POLICE DEPARTMENT VIDEO SYSTEM

INVITATION TO BID – REQUISITION NO. 2019-0314

ADDENDUM NO. FOUR (4) – DATED MARCH 16, 2019

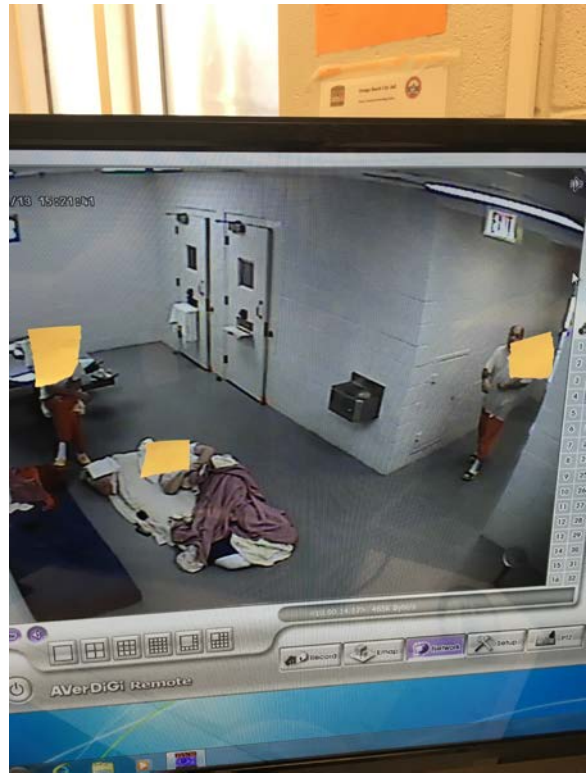
Question 4: Is it possible to get a snapshot of the current camera view in Day Room A, B and D? I would like to see what blind spots exist with your current cameras.

Answer: All three rooms, A, B, and C have the same. The blind spot is under the camera. We do not want to view the area to the left where the shower is located.
